## RESPONSE TO REQUEST FOR ADDITIONAL INFORMATION

### APR1400 Design Certification

Docket No. 52-046

RAI No.: 412-8525  
SRP Section: 08.04 – Station Blackout  
Application Section: 8.4  
Date of RAI Issue: 02/22/2016

Figure 1 Simplified Electrical Connection Diagram of the AAC GTG

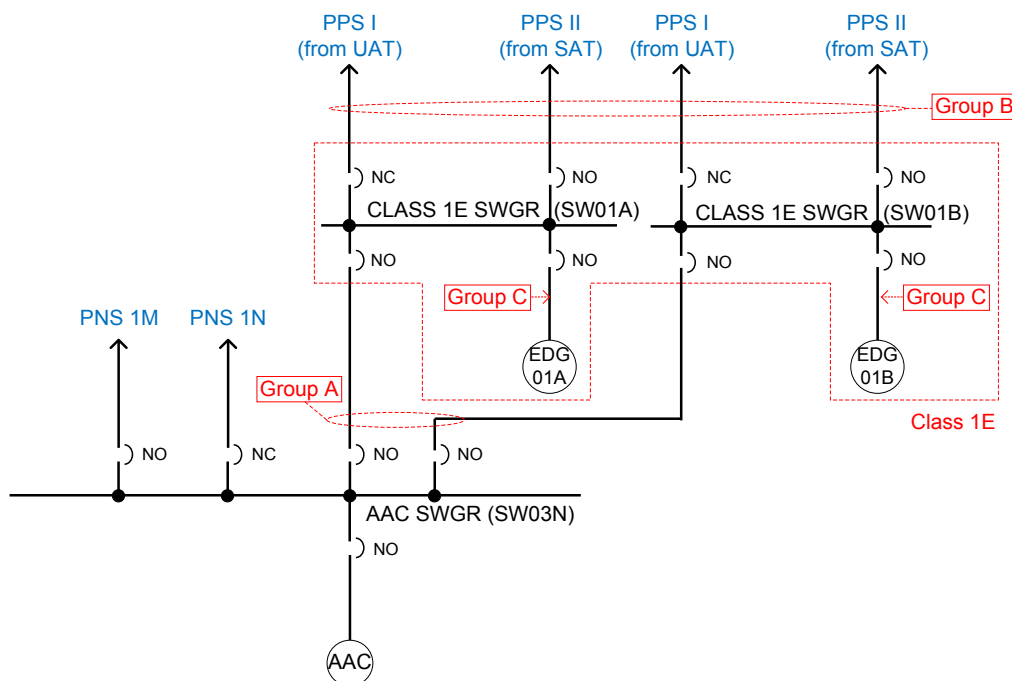
- a. Please provide a description of how the AAC power source is connected to the PPS.
- b. The applicant states: “The connections between the non-Class 1E AAC [switchgear] SWGR 3N and each Class 1E SWGR 1A and 1B are separated from the cables connecting the Class 1E SWGR 1A and 1B to the PPS as practicable such that impact on the connections of the AAC power source is minimized for events that affect the PPS.” Please provide the safety classification of cables connecting the AAC SWGR 3N to the Class 1E SWGR 1A and 1B, the Class 1E SWGR 1A and 1B to the PPS, and the Class 1E emergency diesel generators (EDGs) to the Class 1E SWGR 1A and 1B. Also, please discuss how the APR1400 design conforms to NRC RG 1.75 in regards to the separation of the cables.

- a. The alternate alternating current (AAC) gas turbine generator (GTG) is connected to the non-Class 1E 4.16 kV SWGR 3N (AAC SWGR 3N) through a normally open circuit breaker (CB). The AAC SWGR 3N is connected to each Class 1E 4.16 kV SWGR 1A and 1B through two normally open CBs in series. Since the AAC GTG is aligned to either the Class 1E switchgear 1A or 1B only in the event of a station blackout (SBO), there is no chance of connecting the AAC GTG to the preferred power supply (PPS). To illustrate the electrical connections among the AAC GTG, PNS SWGR, Class 1E SWGR, and PPS, a simplified diagram is provided, refer to Figure 1 below.
